FINAL REVIEW CITY OF ALLENTOWN, PENNSYLVANIA HARB

Case # HDC-2019-00016- Proposal to do façade improvement, restoration and rehabilitation

Property located at: 209 N 10th Street

Historic District: Old Fairgrounds

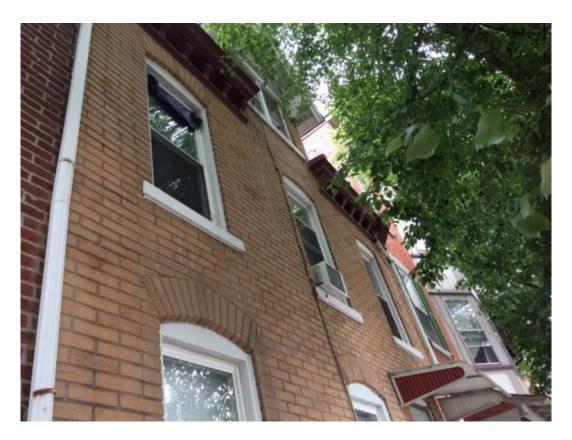
Evaluation, effect on historic district, recommendations: The proposed work is historically appropriate with the following clarifications or recommendations:

- Remove existing brickote with gentlest means possible to limit damage to historic brick.
 Follow Preservation Brief #2 for repointing using a high lime content mortar

- GAF Slateline shingles in Antique Slate color would be appropriate if natural slate financially not feasible
- Removal of the water table stucco is recommended if condition of brick under brickote and existing stucco water table is good

- Installation of a liberty bell style entry roof over the front door may be historically appropriate in this case especially if evidence is found indicating one existed historically. If an entry roof is installed it is recommended to match the roof found at 207 N. 10th.

- It is recommended to remove windowsill and trim capping. Replacing vinyl replacement windows with 1/1 Aluminum clad wood windows is highly recommended

- Replacement of entry door and storm door is historically appropriate. Multi-panel solid,
 13 light Victorian styled glass door matching 207 N 10th, or ¾ /half-light with lower panel type doors would be historically appropriate.

- All other items are historically appropriate with staff approval of light fixture recommended

- a. Brickote and stucco water table will be removed, and historic brick repointed with high lime content mortar as needed. Preservation Brief #2 is to be followed

- b. The existing roofing will be repaired or replaced with natural slate or new GAF Slateline fiberglass shingles (or equivalent)
 - c. Vinyl windows will be replaced, if possible, with aluminum clad wood windows to fit the historic openings. All aluminum capping will be removed.

- d. The existing front door will be replaced with an historically appropriate solid multi-panel door, a 13 light Victorian styled glass door matching (or similar to) 207 N 10th, or ¾ /halflight with lower panel type door. The existing storm door will be replaced with a bronze aluminum full light storm door.

- e. The existing aluminum door awning will be removed, and a Liberty Bell style entry roof installed over the front door and steps. The Liberty Bell roof will match the shape and design of the neighboring roof.

- f. All woodwork will be repaired in kind and repainted.
 - g. The missing finial on the grocer alley gate will be replaced in kind and all iron work will be painted flat black.

- h. Existing downspout will be replaced with new round downspout, if needed

- i. A new porch light will be installed; specifications to be submitted for staff reviewj. Street address will be installed on new door transom in gold leaf historic font or on front door frame.
